**From:** Scala, Mary Joy  
**Sent:** Monday, June 23, 2014 3:06 PM  
**To:** Tolbert, Jim  
**Cc:** Brodhead, Read  
**Subject:** FW: Battle signage specs  
**Attachments:** 24103\_GropenInc\_BattleChildren\_Exterior\_draft4.pdf

Client:  
**Battle Children's Hospital**  
 Kjellstrom and Lee

Project:  
 Exterior Signage

Scale: 1/4" = 1'-0"  
**East Elevation - UVA Health System Logo - Enlarged View**

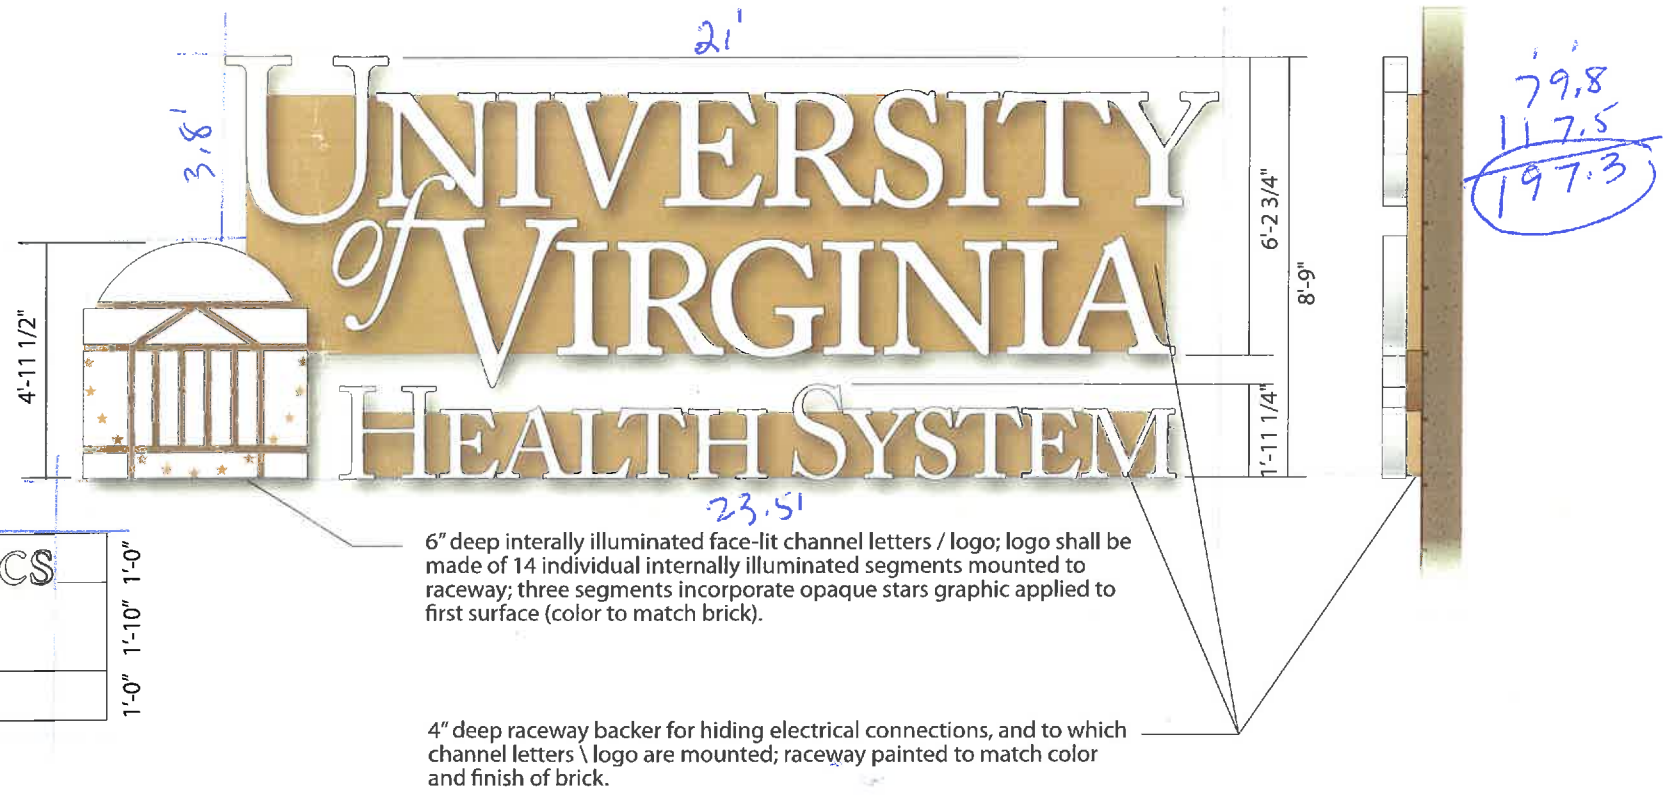
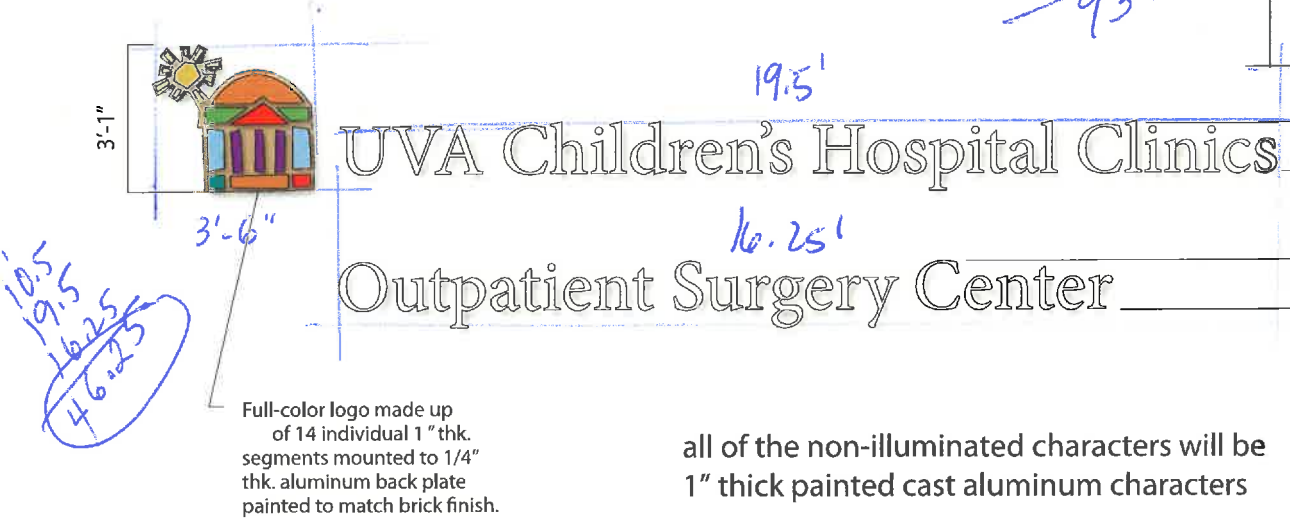
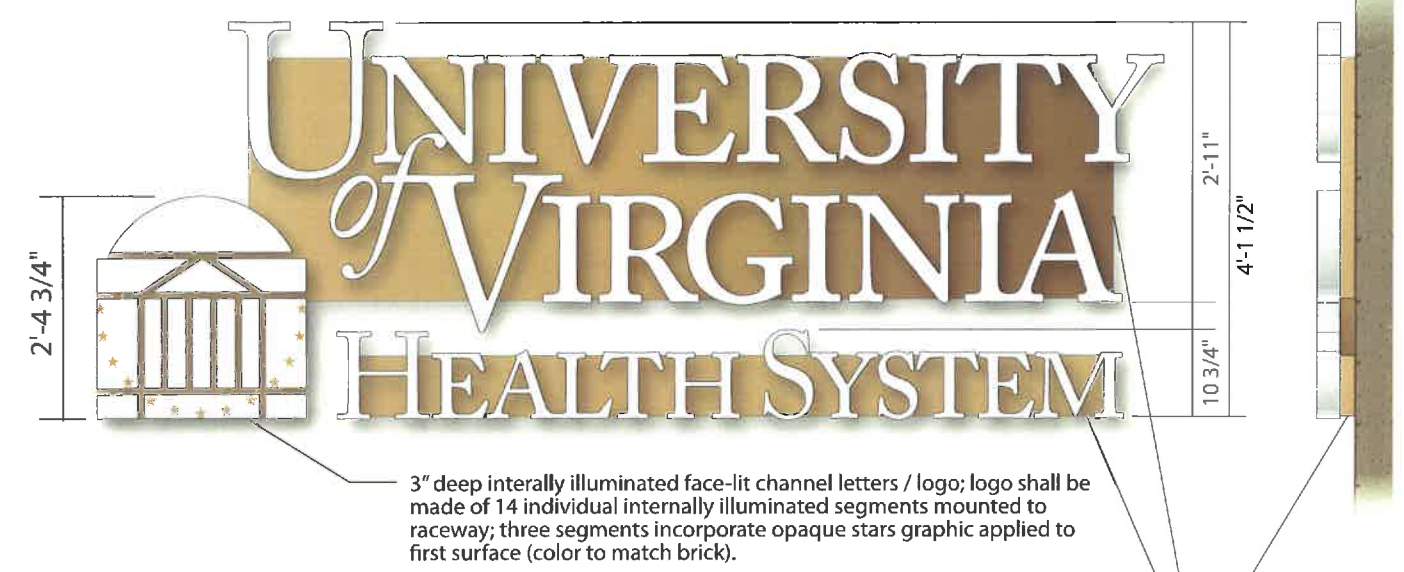
University of Virginia Health System - 197.3 sq ft  
UVA Children's Hospital Clinics – 30 sq ft  
Outpatient Surgery Center – 16.25 sq ft  
Total East side= 243.55 sq ft

Regarding lighting, West Main Street ADC prohibits internally lit signs except for internally lit channel letters or neon signs. The color and method of lighting of the existing signs are appropriate; the size and placement of the east side signs are not appropriate.

**They need to remove all the signage on the east side, and if they want more signage for the entire building, they must apply for a comprehensive signage plan. I would not recommend any wall signage to be placed above twenty feet.**

**SBS Note: All dimensions to be field verified. Please provide letter face material and face retainer system details (e.g. 3M diffusion film included on face's 2nd surface to ensure no hot spots.). Please provide elevation(s) indicating LED layout / spacing and power provisions; contractor is responsible to ensure NO hot spots on face of sign from illumination.**

Scale: 1/4" = 1'-0"  
**West Elevation**

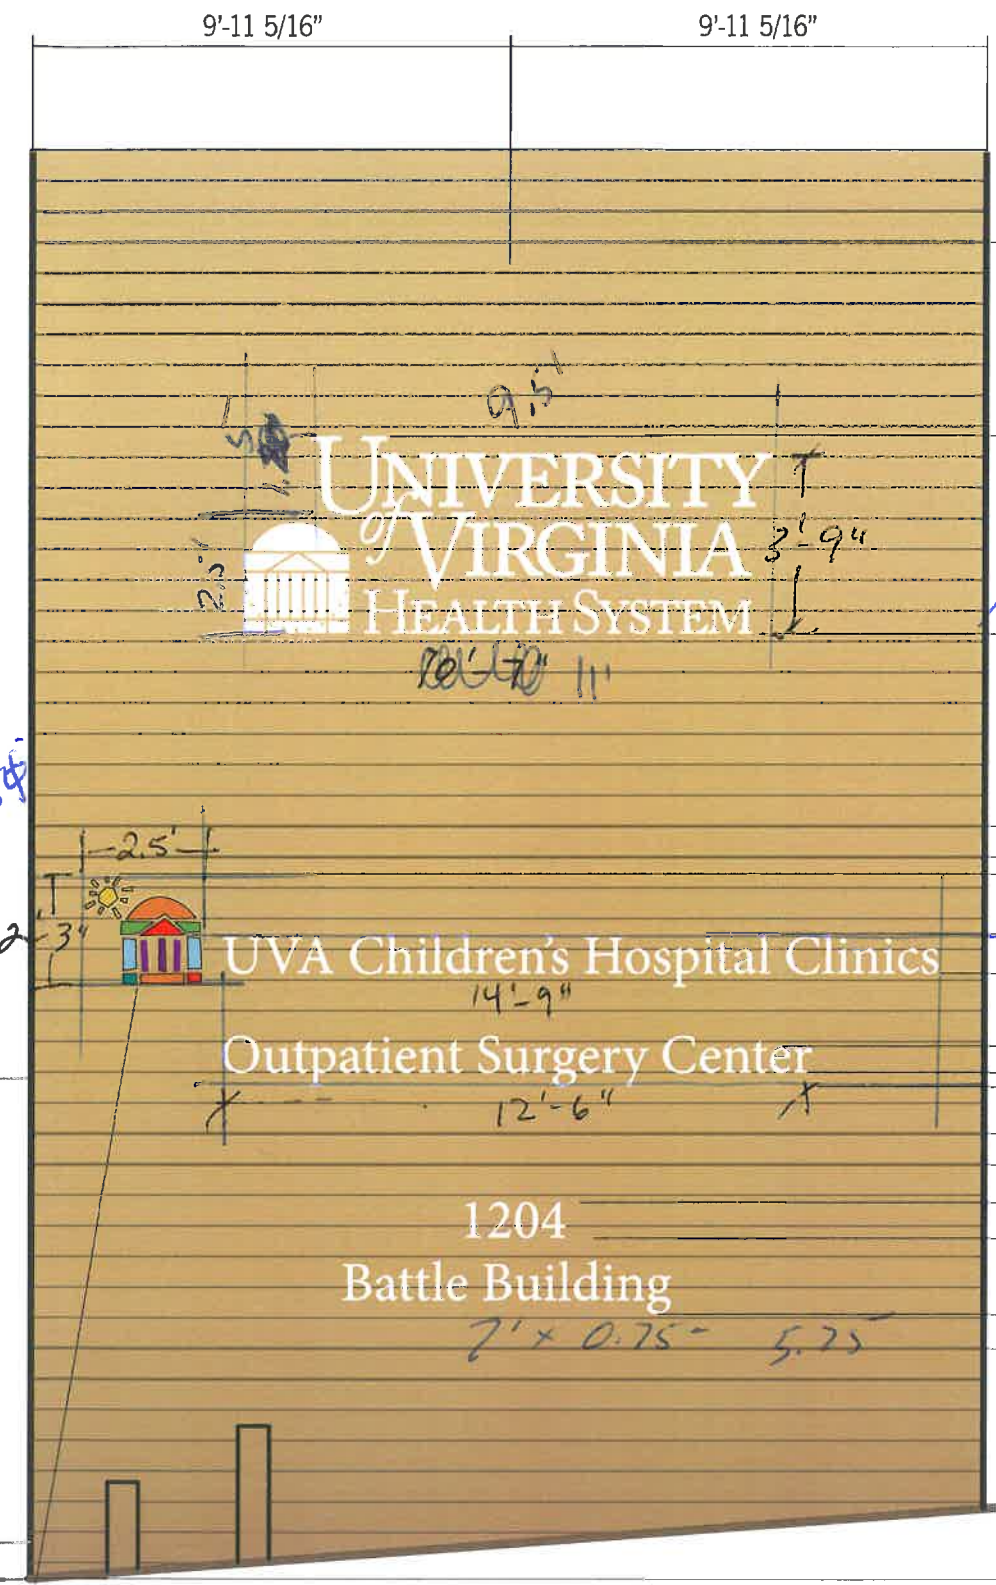
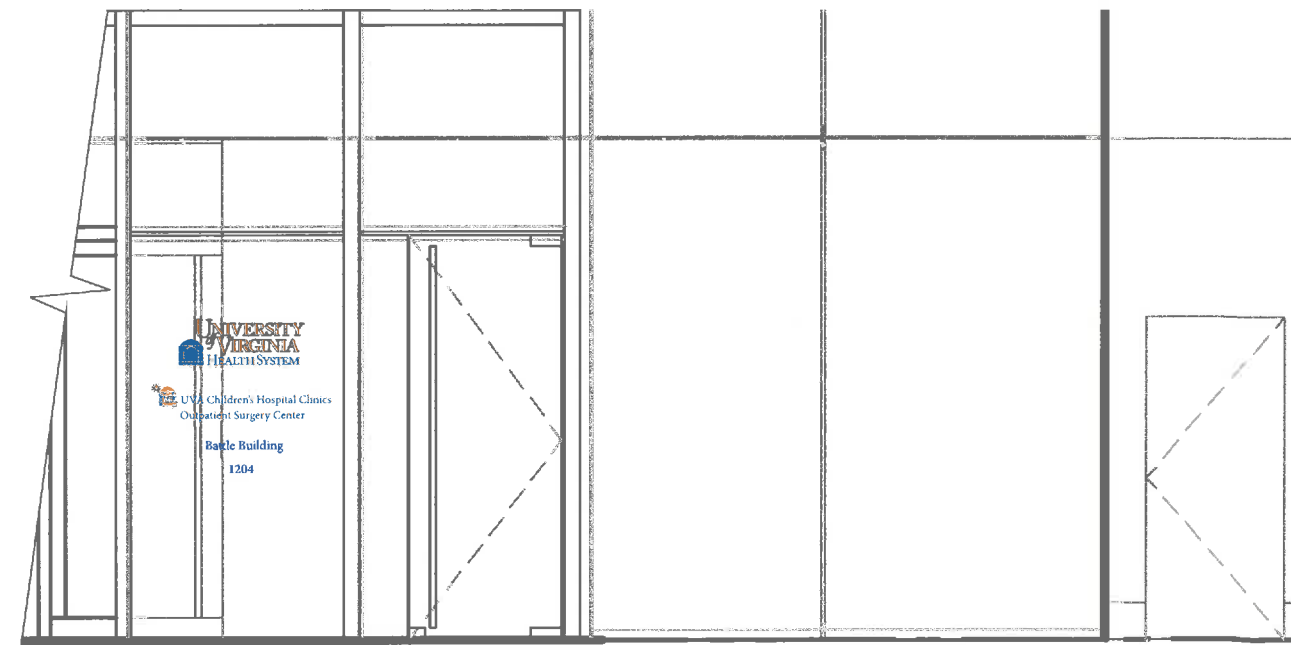
University of Virginia Health System - 41.75 sq ft  
UVA Children's Hospital Clinics Outpatient Surgery Center - 50 sq ft  
1204 Battle Building – address not counted  
Total West Side = 91.75 sq ft

( The one on the west side of the building exceeds 90 sq ft) Therefore, without a comprehensive signage plan in place, they cannot have any additional wall signage except for retail tenants.

Handwritten calculations:  
 $63 \phi$   
 $5.25$   
 $68.25$   
 $14.25$   
 $27.50$   
 $41.75$   
 $39.4 \phi$

TYPICAL SIGN FRAME ELEVATION

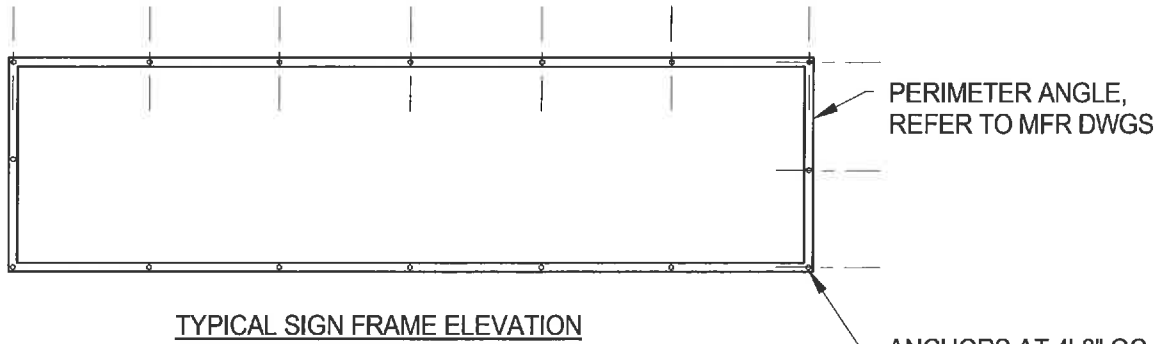
SBS Note: Gropen clarified that this detail applies to Sign Type X2A and X2B
